SERVICE BULLETIN

APPLICABILITY: 2014-15MY Forester Models
 2012-15MY Impreza and XV Crosstrek Models
 (EXCEPT Hybrid)

NUMBER: 06-50-15
DATE: 08/10/15

SUBJECT: Design Changes to Master Cylinder and Brake Booster

MASTER CYLINDER ASSEMBLY

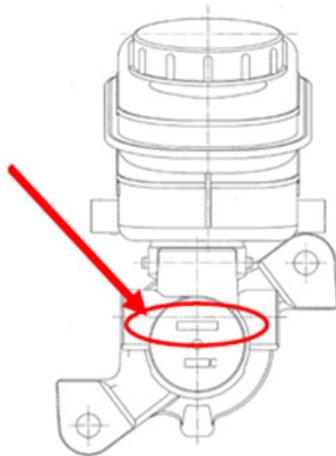
CAREFULLY inspect the 5 digit ID located on the front of the Master Cylinder to determine if it is a “new” or “old” part. If the ID is: **FJ120** or **FJ130**, it is a “new” part.

If there is a white dot paint marking on the Vacuum Booster, it is a “new” part.

ID (Last 5 digits of the part number)
Example FJ120

“New” part has a white dot paint mark.

NOTE: It is especially important to verify the ID of both parts on vehicles with VINs found to be within the Transition Period. Whenever unable to positively identify either component, replace **BOTH** as a set using the “new” part number parts.
